**BELLEVUE PLANNING AND ZONING COMMISSION  
PUBLIC MEETING NOTICE and AGENDA  
November 26, 2019 at 2:00 P.M.  
IN BELLEVUE CITY HALL  
115 East Pine, Bellevue, Idaho**

<b>REGARDING AN APPLICATION OF:</b> Jose Baeza for Design Review approval for an ADU at 361 Ridgeview Drive, Bellevue. The legal description of LOT 7 BLK 1, Sunrise Ranch Subdivision.	<b>STAFF REPORT</b> By: Ashley Dyer, Community Development Assistant Date: November 19, 2019
--	--

**REQUESTED ACTION:** Design Review approval for a 537 square foot ADU, located at 361 Ridgeview Drive, Bellevue. The legal property description is LOT 7, BLK 1 Sunrise Ranch Subdivision.

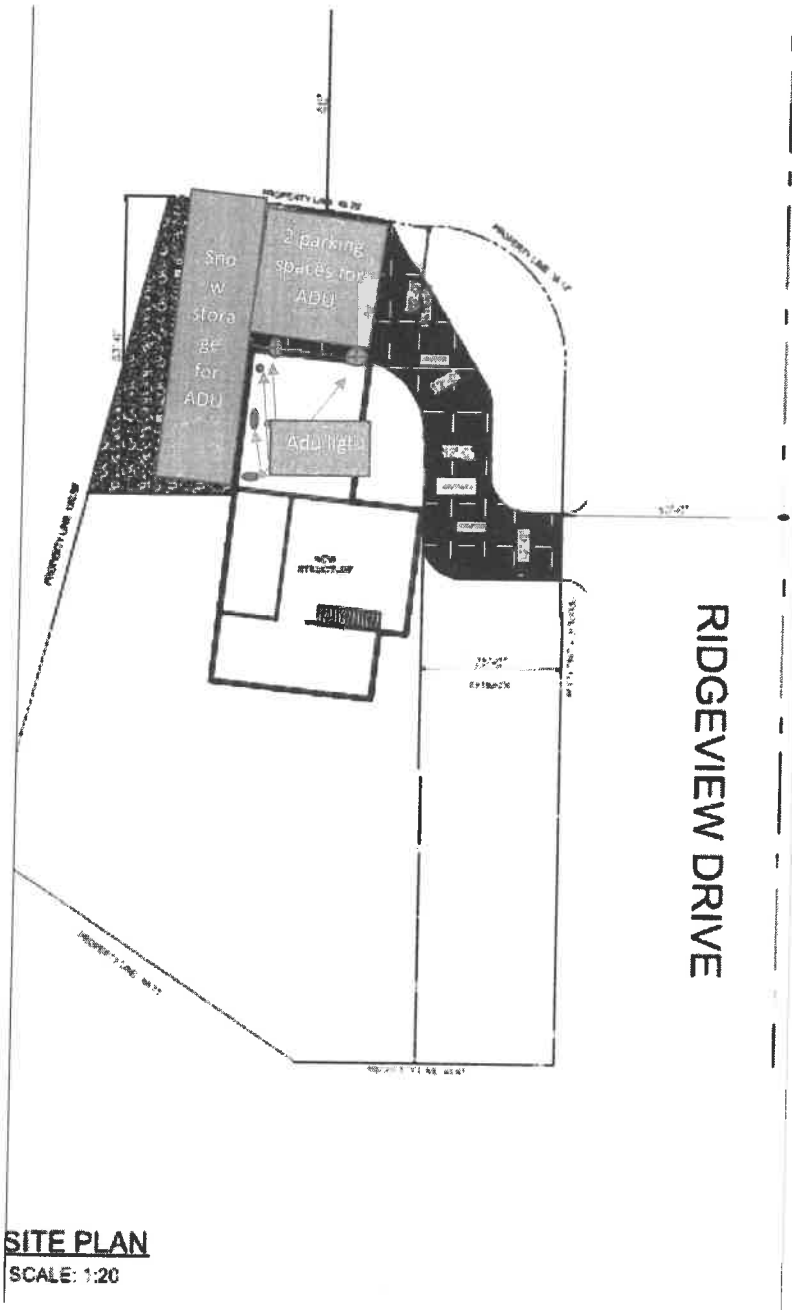
*Zoning Commission. The Commission may impose such restrictions on snow removal operations as are necessary to reduce the effects of noise or traffic on surrounding areas. The applicant proposes a snow storage area in the gravel area by the driveway, where he will be storing the snow for the single-family residence as well.*

*3) Visual impact of on-site parking, service, trash and loading areas shall be minimized, whenever possible, by locating these areas to the rear of the building and providing screening with landscaping or fences from adjacent properties and public ways. Applicant proposes to store the trash container in the garage and take it out for collection.*

*5) Building and parking areas shall be designed to provide proper ingress and egress; safe, adequate and efficient pedestrian and vehicular traffic circulation; and shall provide for the efficient and safe arrangement of on-site parking, building location, and circulation. The existing driveway for the single-family home is large enough to store the required 2 cars for the ADU as well.*

**10-17-5-C Landscaping – Parking – Lighting** Exterior light fixtures and signs shall be non-glaring in design and installation so as not to adversely affect adjacent properties and public ways. The proposed exterior lighting complies with the city code.

*2) Site conditions, drought tolerance and local hardiness shall be considered to select appropriate plant species, including grasses for lawn areas. Applicant proposes to keep all existing landscaping and is not planning on adding anything for the ADU.*

*3) Installation of adequate drip or other low consumption irrigation systems shall be required. Landscaping shall be properly irrigated and maintained, and landscaping, or any portion thereof, shall be replaced when it dies or is otherwise destroyed. An automatic sprinkler system is planned for the front lawn of the single family residence.*

*4) Adequate drainage shall be provided on-site. The applicant has adequate drainage on the property.*
